# ADDENDUM

Project:	Arlington Woods Free Methodist Church Renovation	Post Tender Addendum No.:	A01
Tender #	N/A	No. of Pages:	18 (including cover page)
Project #	1846	Date:	November 06, 2020

- 1.1 Incorporate Changes identified in Architectural Post Tender Addendum No. A01 (12 pages) prepared by Hobin Architecture Incorporated and attached.
- 1.2 Incorporate Changes identified in Mechanical Addendum M2/R1 (3 pages) prepared by Goodkey Weedmark & Associates and attached.
- 1.3 Incorporate Changes identified in Mechanical Addendum E1/R1 (2 pages) prepared by Goodkey Weedmark & Associates and attached.

DRAWING NAME:  
**WASHROOM  
ELEVATIONS**

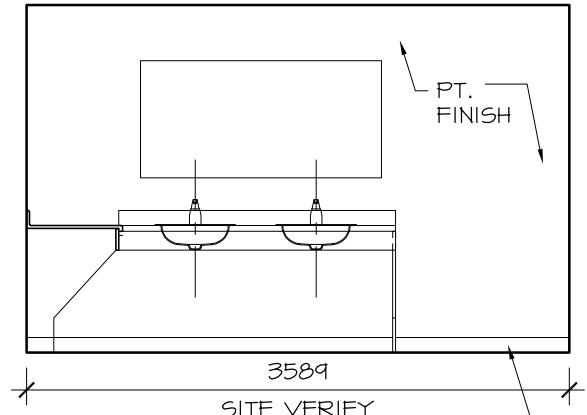
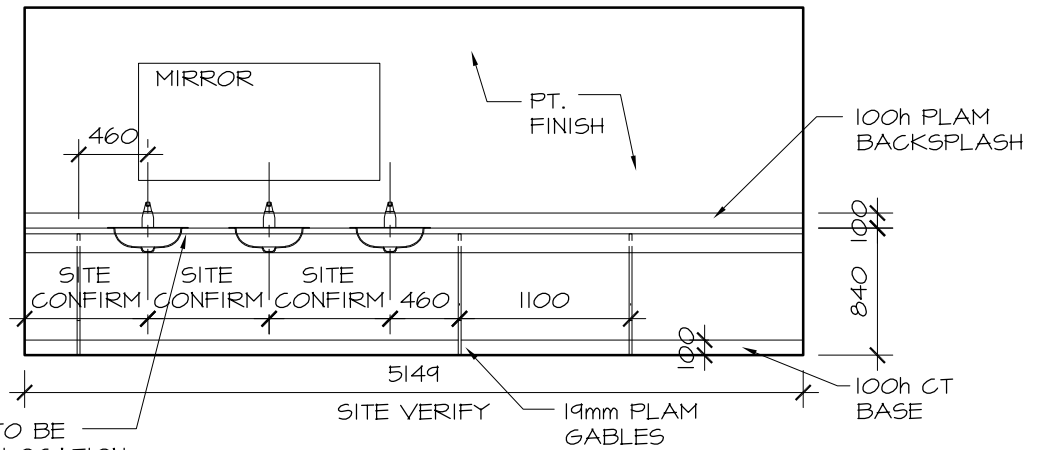
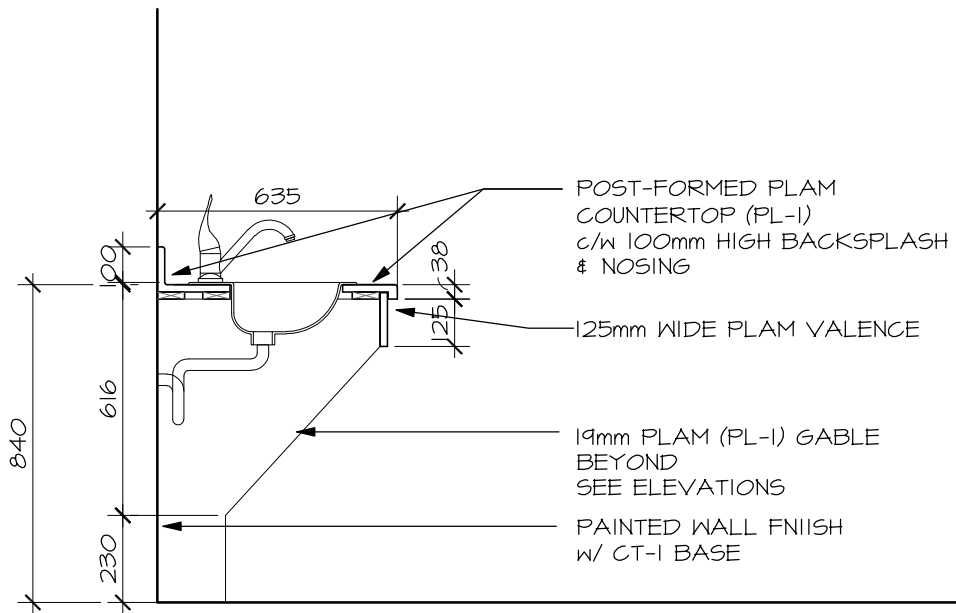
Item No.	Drawing or Spec Section	Description
<b>PT-A1.1 General</b>		
PT-A1.1.1	A2.04 Section 08 00 00.01 – Door Schedule	<b>Door 106.1:</b> Revise new door opening to existing door 106.1 from 860mm to <b>915mm (36")</b> .
PT-A1.1.2	10 21 13.13	<b>Metal Toilet Compartments:</b> Replace two (2) existing toilet partitions in Men's WR 107 and four (4) existing partitions in Women's WR 109 with new metal toilet partitions and all associated hardware. Refer to the attached Specification Section 10 21 13.13. Re-install existing washroom accessories on new toilet partitions. Refer to the attached <b>Architectural Sketches PT-ADD-01.01 &amp; PT-ADD-01.02</b> .
PT--A1.1.3	A2.04	<b>Coats 101A:</b> Refer to the attached <b>Architectural Sketches PT-ADD-01.03</b> for interior elevations of Coat Room 101A. Carefully remove existing aluminum coat racks and hangers in existing Coat Room and store for re-use. Modify racks to suit new Coats 101A configuration and re-install on existing walls. Equally space brackets to suit configuration as shown on ADD-03.03. Cut and patch existing drywall to install wood blocking as required to suit bracket locations. Centre coat rack at 1830mm A.F.F.

EXISTING FIXTURES TO BE  
REPLACED IN SAME LOCATION  
TYP. SEE MECH. DWGS.

ADD-E1-R1-SK1

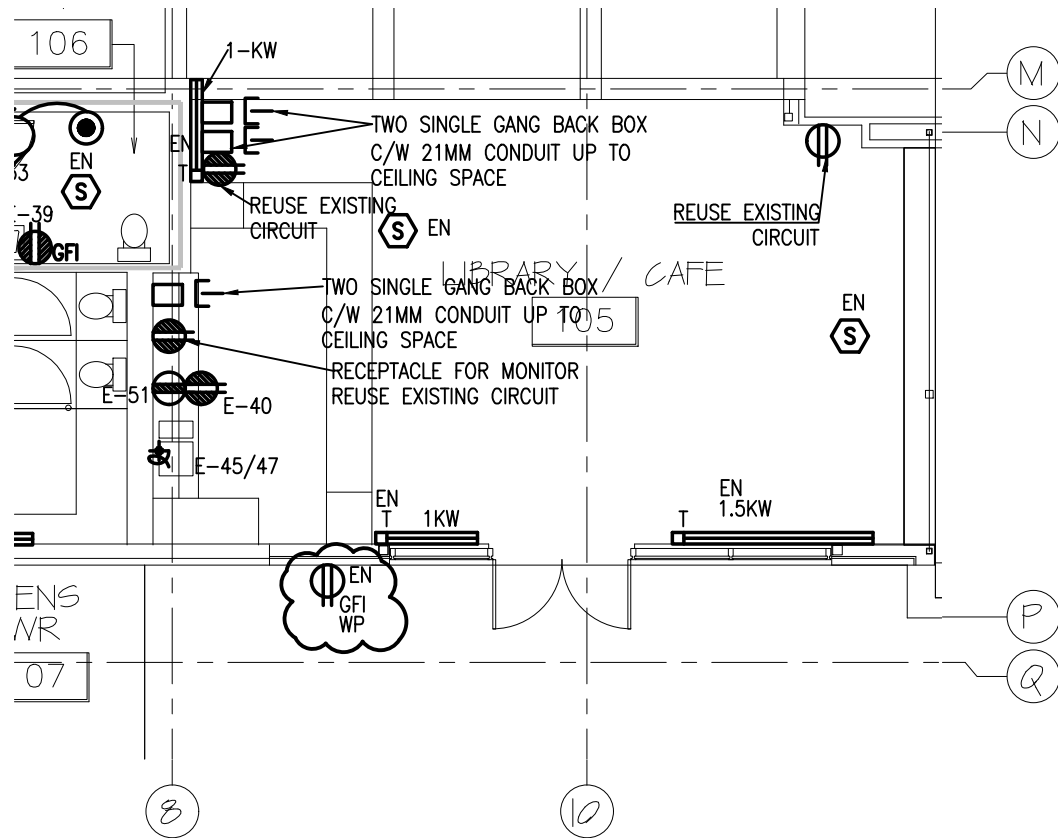
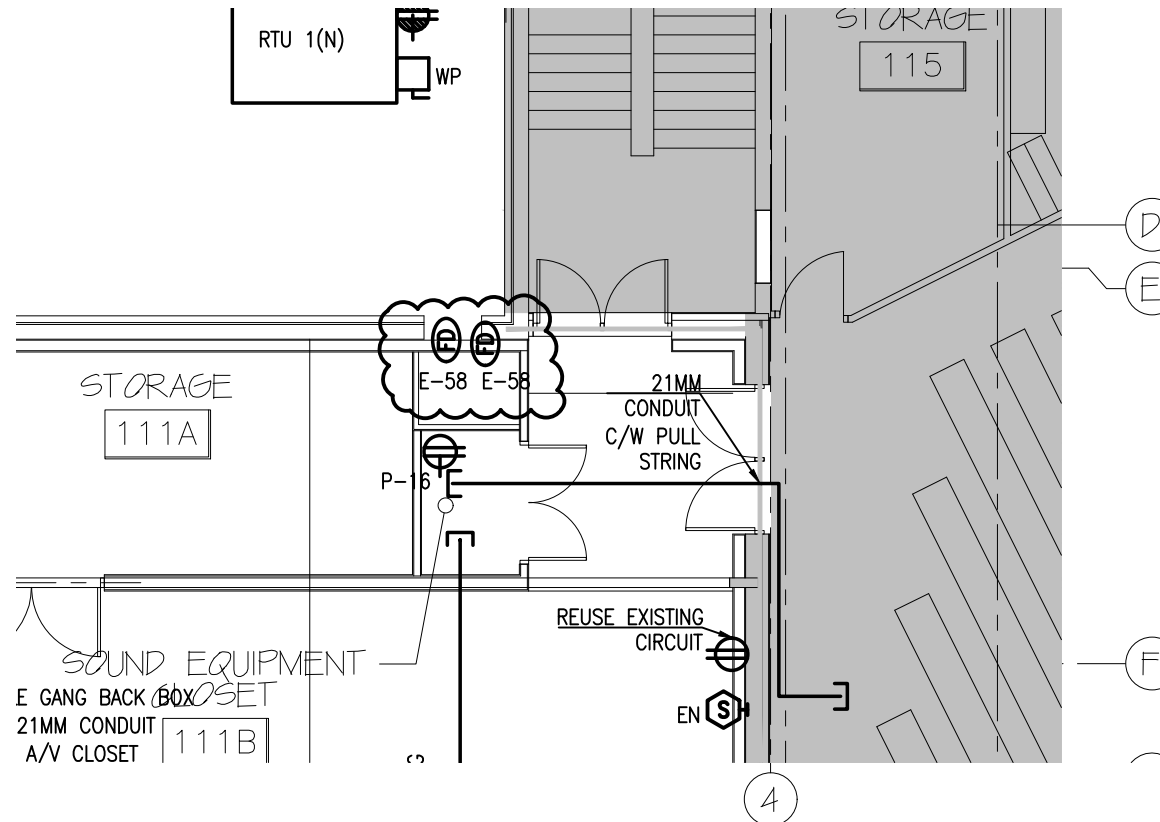
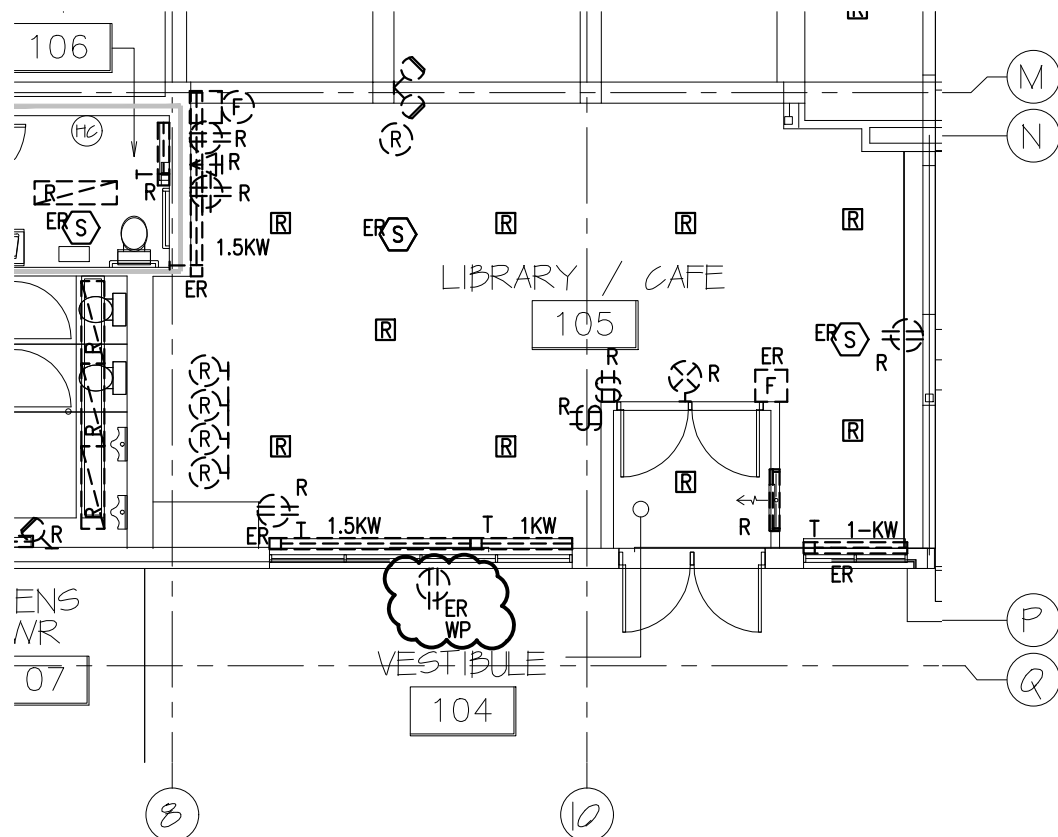
### 1. Reference Drawings E6 & E10 and Attached Revised Sketch ADD-E1-R1-SK1:

- .1 Disconnect and remove existing exterior weatherproof receptacle c/w conduit and wire back to junction box. Extend existing wiring and provide new weatherproof GFI receptacle c/w conduit as indicated in attached revised sketch ADD-E1-R1-SK1.
- .2 Provide 120V wiring to fire damper (total QTY. 2) located on Room 111B. Coordinate exact location with mechanical contractor. Circuit as indicated.
